PD Modification Application: MM 25-1242

Hillsborough County Florida
Development Services Department

Introduction Summary:

The Applicant requests a major modification to the existing Planned Development (PD 24-0124) for a ±11.43-acre property in the East Lake Orient Park Community Plan Area. The PD is currently approved for 71 dwelling units, including 14 two-family attached (duplex) units and 57 single-family attached (townhome) units. The proposed modification seeks to revise the development plan to allow 86 single-family attached (townhome) units, eliminating the duplex units and increasing the total unit count. The proposed plan includes updated site development standards.

8.2 Proposed Site Plan (Full)

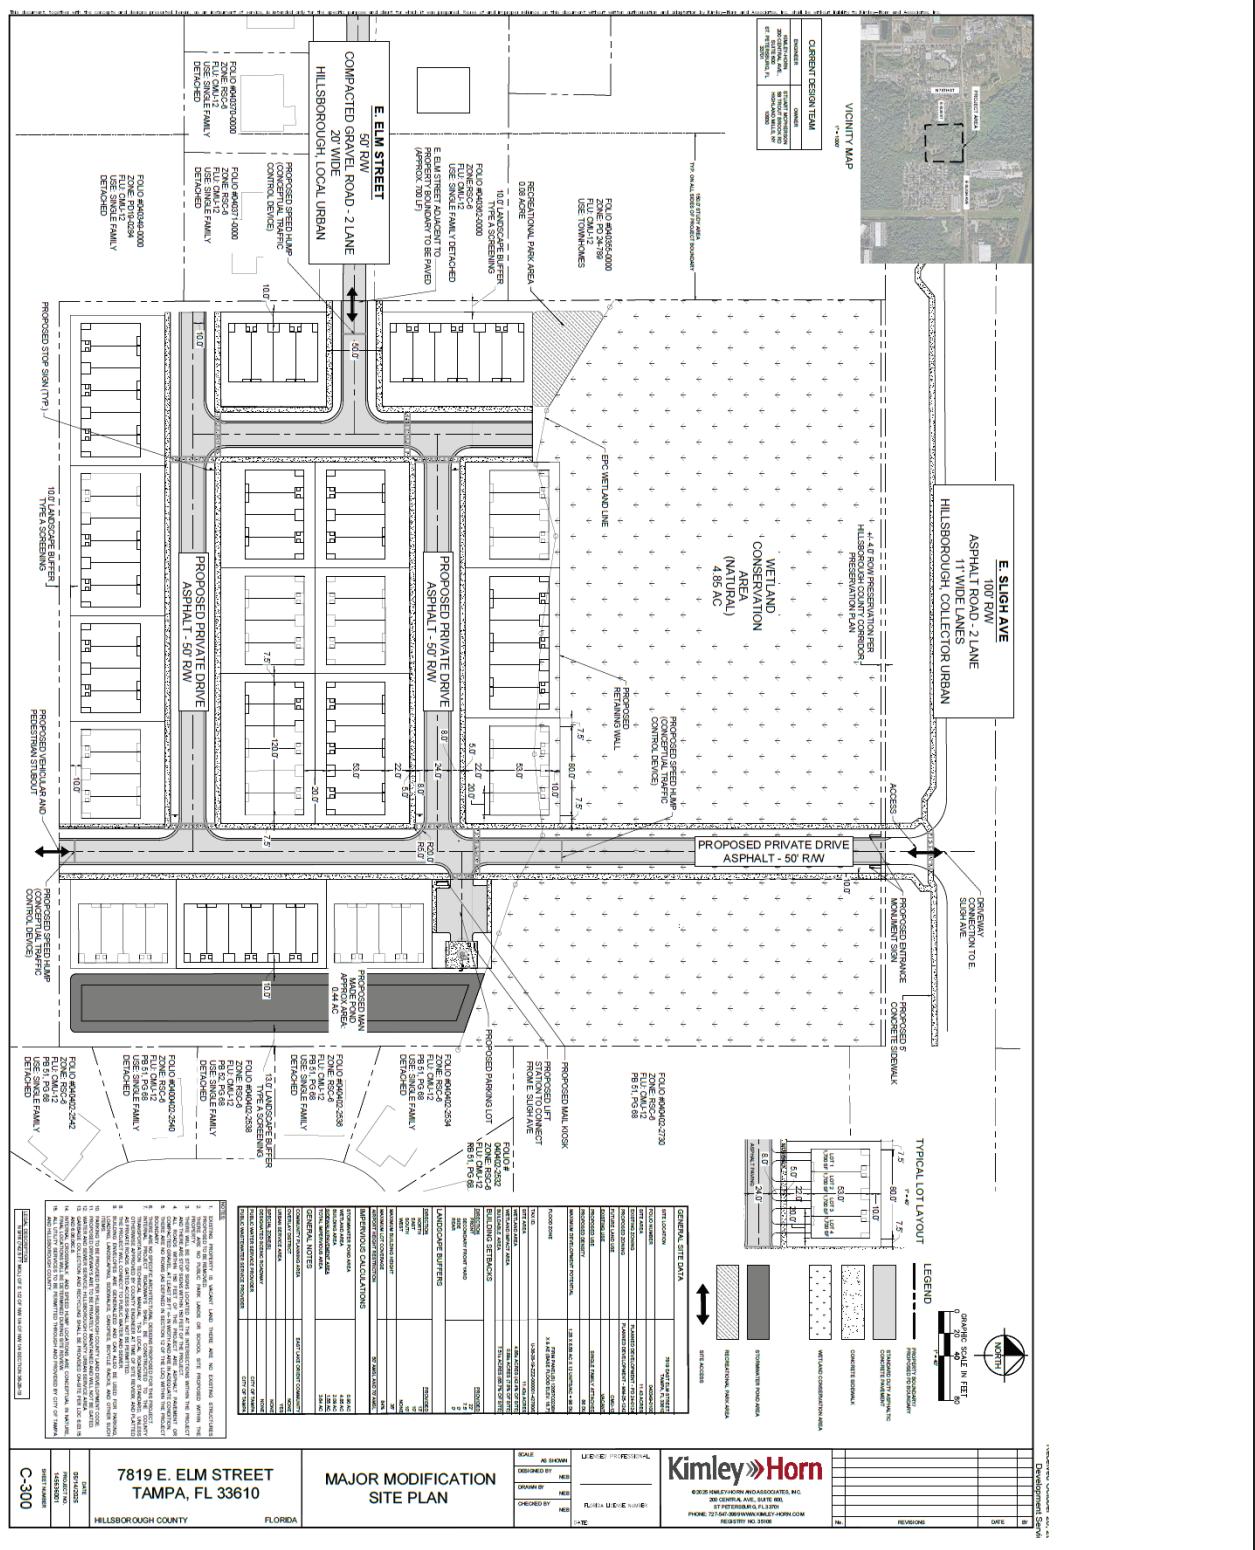
Prior to certification, the applicant shall make the following revisions to the PD site plan:

1. Update the general site data table to note that the 0' setback is to the lot line, not the PD boundary and that indicated 10' on the lot detail is actually the buffer area.
2. Update the general site data table to correct the landscape buffers to match what is depicted on the site plan.
3. Update the general site data table to note the maximum lot coverage of 87%.

Approval of the request, subject to the conditions listed, is based on the revised general site plan submitted October 28, 2025.

Figure 2: Proposed Typical Section

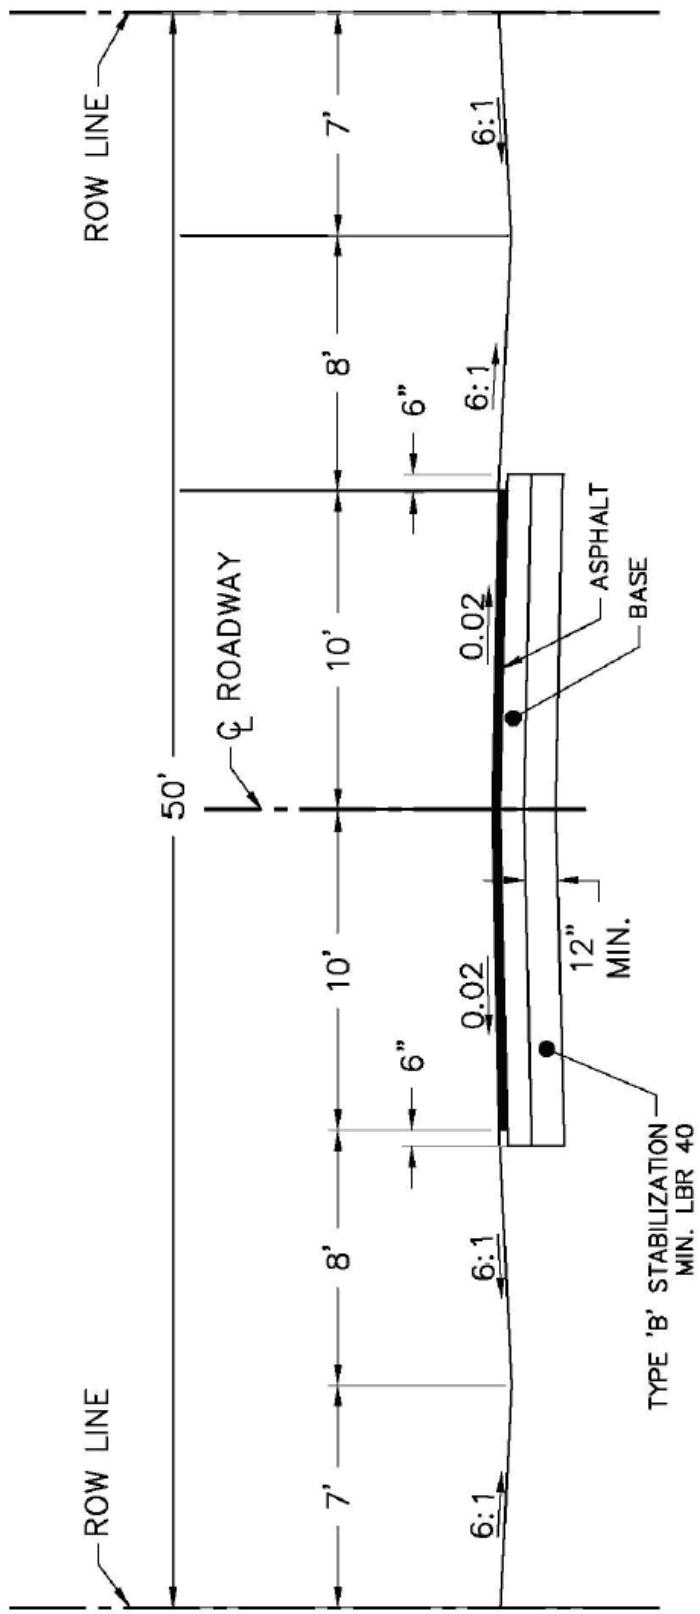
Elm Street is identified in the Hillsborough County Comprehensive Plan as a local roadway and during our meeting was identified as a substandard road. Elm Street does not have a posted speed limit but was assumed to be 25 mph based on the characteristics of the roadway. The existing paved section of Elm Street is approximately 475 feet long with 10-foot travel lanes, unpaved shoulders and a very shallow open ditch within approximately 50 feet of right of way. There are no sidewalks on either side of the roadway. No bike lanes currently exist on either side of Elm Street.

3. No sidewalks are being provided along Elm Street as the internal project roadways will provide sidewalks and pedestrian/vehicular connection to Sligh Avenue. As part of this development, a separate Design Exception for Sligh Avenue will provide for a sidewalk along the south side of Sligh Avenue from Orient Road to the eastern project boundary.

The County Engineer has reviewed zoning modification application # 25-1242 and determined the changes to be de minimis. As such, the previous approval shall stand.

Figure 2: Proposed Western Typical Section

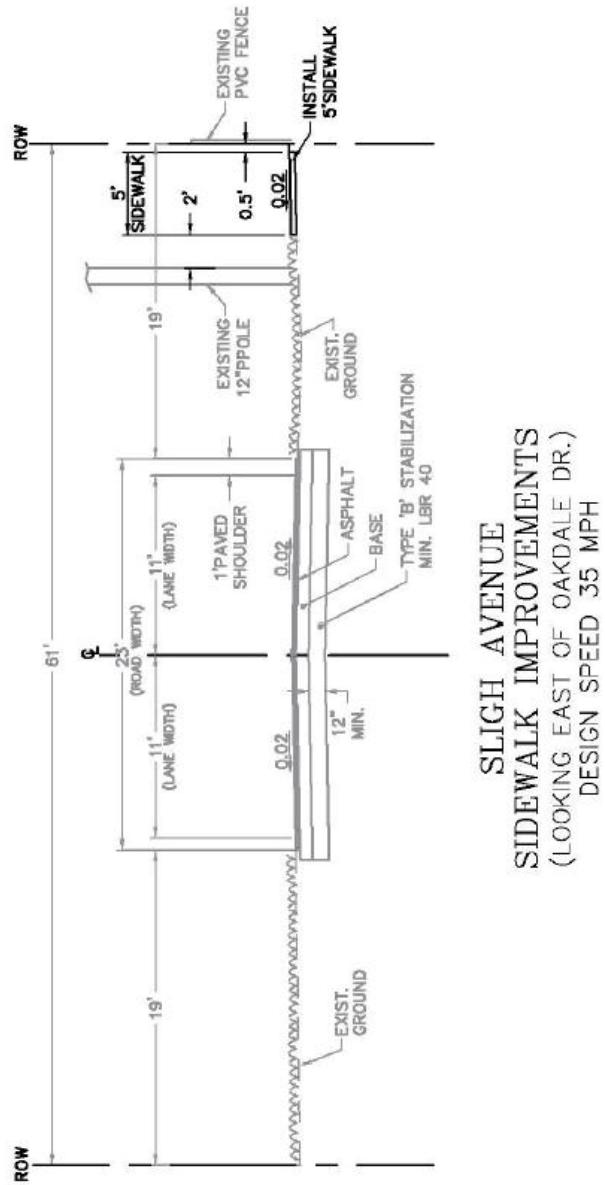
1. The existing ROW along Sligh Avenue is approximately 61.5 feet. The typical TS-7 section for a rural, two-lane undivided roadway requires a minimum of 96 feet of ROW with 12-foot lanes, 5-foot paved shoulder, open drainage, and a 5-foot sidewalk.
2. The request is to maintain the existing 11-foot travel lanes and relatively flat shoulder/open drainage. The missing segments of the 5-foot sidewalk on the south side of the road will be completed which will add approximately 350 linear feet of sidewalk. Based on Table 210.2.1 of the FDOT Design Manual, the 10-foot travel lanes are identified as acceptable.

The proposed Western typical section is shown in Figure 2 and the proposed improvements are shown in Figure 3.

The County Engineer has reviewed zoning modification application # 25-1242 and determined the changes to be minimis. As such, the previous approval shall stand.

Figure 4: Proposed Eastern Typical Section

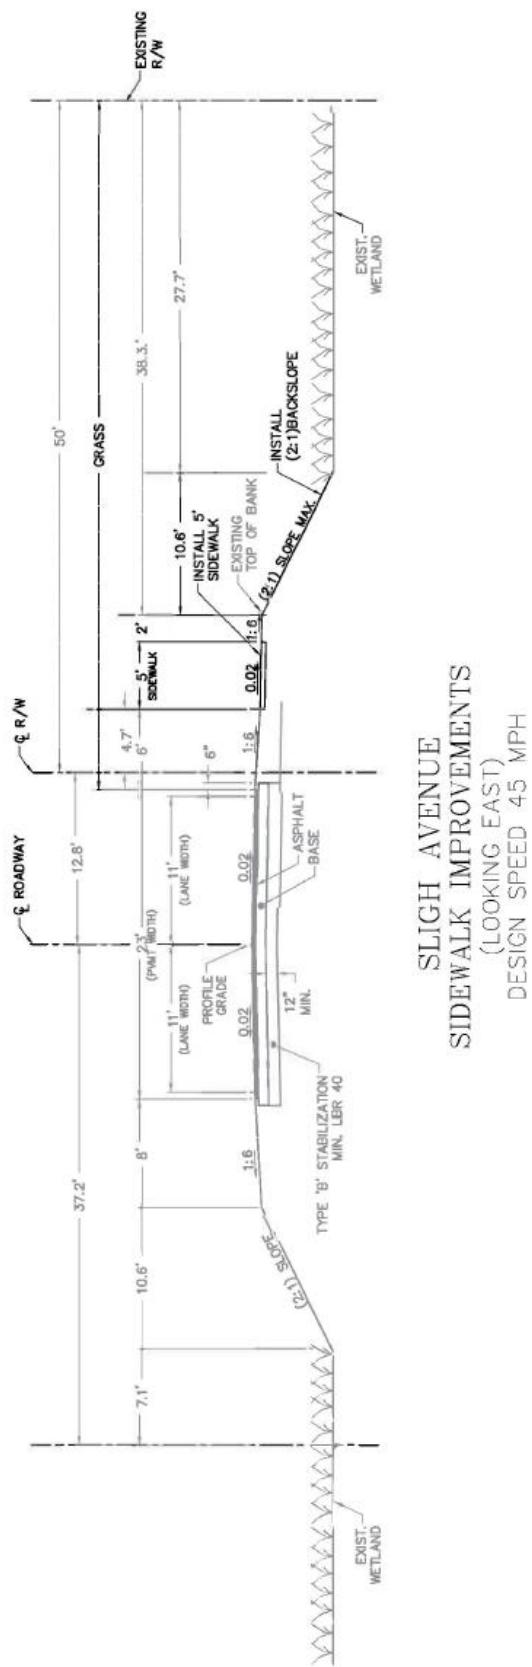
1. The existing ROW along Sligh Avenue is approximately 100 feet, however, there is an existing wetland within the existing ROW along both sides of the roadway. The typical TS-7 section for a rural, two-lane undivided roadway requires a minimum of 96 feet of ROW with 12-foot lanes, 5-foot paved shoulder, open drainage, and a 5-foot sidewalk.
2. The Eastern Section currently has 11-foot travel lanes in approximately 100 feet of right of way. The request is to maintain the existing 11-foot travel lanes and add approximately 1,300 linear feet of 5-foot sidewalk on the south side of the roadway, with a 6-foot grass strip on the south side and a 2-foot grass strip behind the sidewalk. Due to ROW constraints and existing conditions, the slope to the wetland may exceed to 1:4 side slope but will not exceed 1:2.

The proposed Eastern typical section is shown in Figure 4. Please do not hesitate to contact us if you have any questions or require any additional information.
